# NuScale DC Application Design Basis Failed Fuel Fraction Issue

September 2017

# Staff Evaluation - Overview

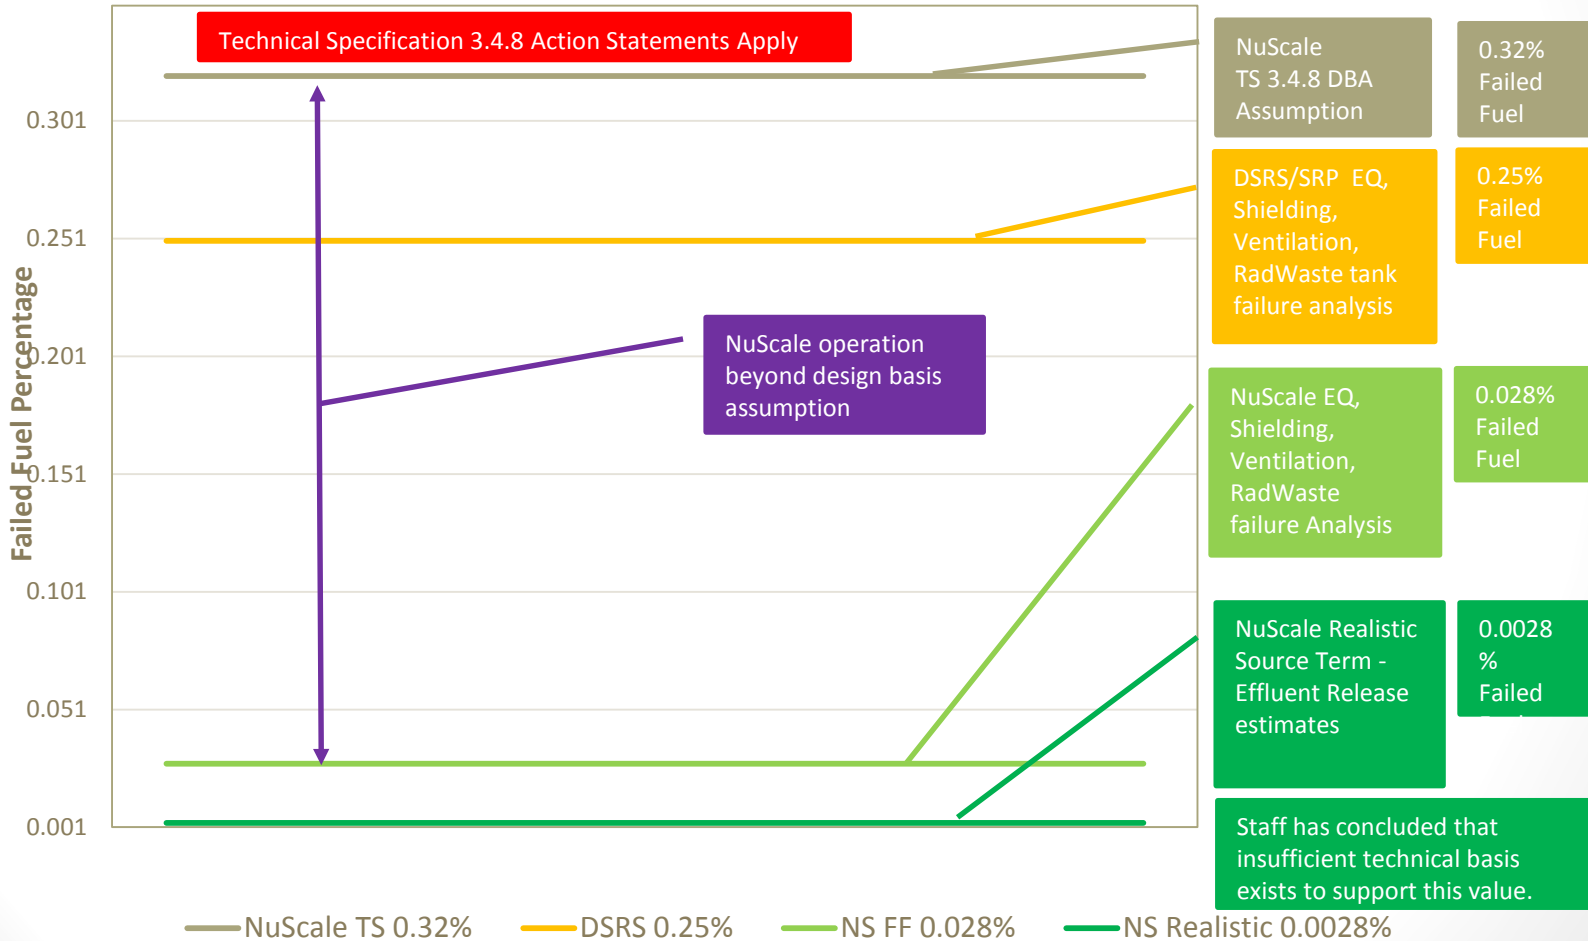
- For an unproven and untested fuel design, a reasonably conservative approach for establishing the technical basis for the design basis failed fuel fraction is necessary
  - Operating experience has shown that fuel failures continue to occur in light water reactors
  - NuScale has not provided sufficient technical basis for its proposed design basis failed fuel fraction
  - NuScale has not proposed regulatory controls to preclude operation above design basis failed fuel fraction
